**Details pursuant to Condition 1 and 2
(part) of a Full Application, reference
6/2016/0995/FULL and Listed Building
Consent 6/2016/0347/LB for an Erection
of a single Storey Rear Extension and
Internal Alterations at Oshwal Centre
Coopers Lane Road Northaw Potters
Bar EN6 4DG.**

15 April 2017

Saloria Architects Ltd

3.3.8 The following two images show the differences between the type of window proposed in the previous application for condition, ref.: 6/2017/2592/COND (image above) and the present application for the same conditions (image below).

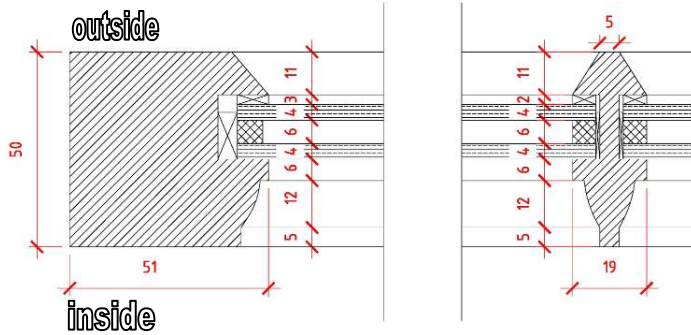
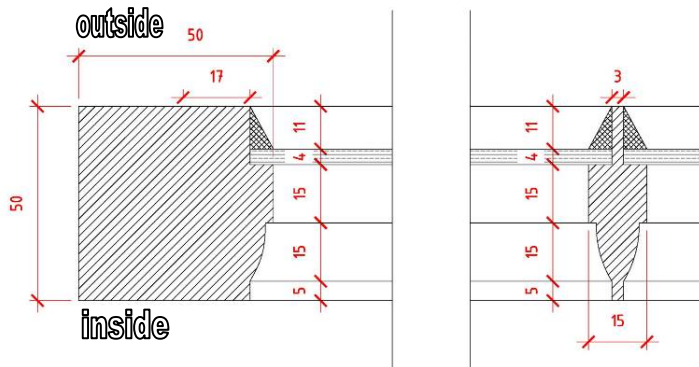
3.3.5 A previous application was submitted to respond to this condition (see ref.: 6/2017/2592/COND. Objections were raised to the details submitted for the windows and doors as they would not be slim-profile, double-glazed and would have surface-mounted glazing bars. As such, the proposed windows and doors would not be in keeping with the character of the listed building.

3.3.6 To respond to those previous concerns it has been opted for timber frame sash-windows and doors. They will be single glass panes with traditional muntin and not surface-mounted glazing bars.

3.3.7 The panes will be slim line double glazing (4-6-4) to replicate the slim profile of the existing windows as well as trying to reach the right rate of sound passage, protection from impact, insulation and U-value according to the Building Control Approved Document Parts E, K and L.

Sash window frame in composite material (timber and aluminium) object of the application for conditions ref.: 6/2017/2592/COND (image not in scale).

New proposed section of the thin line timber frame and the muntin (4-6-4) (image not in scale).

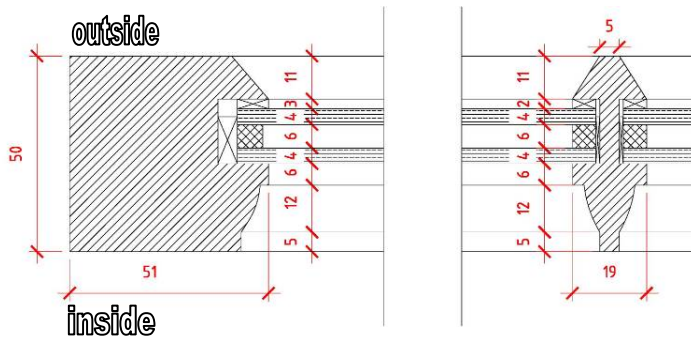
3.3.9 The following images show there will be no particular difference in details between muntin, compared to the existing sash windows. The shape of the frame and the muntin will be the same. The minor differences are due to the different obligations under policies within the Building Control Approved Document Part K.

Existing section of the frame and the muntin (image not in scale) (abstract of details from the survey and drawing attached to application 6-2018-0136-LB).

Proposed section of the thin line frame and the muntin (4-6-4) (image not in scale).
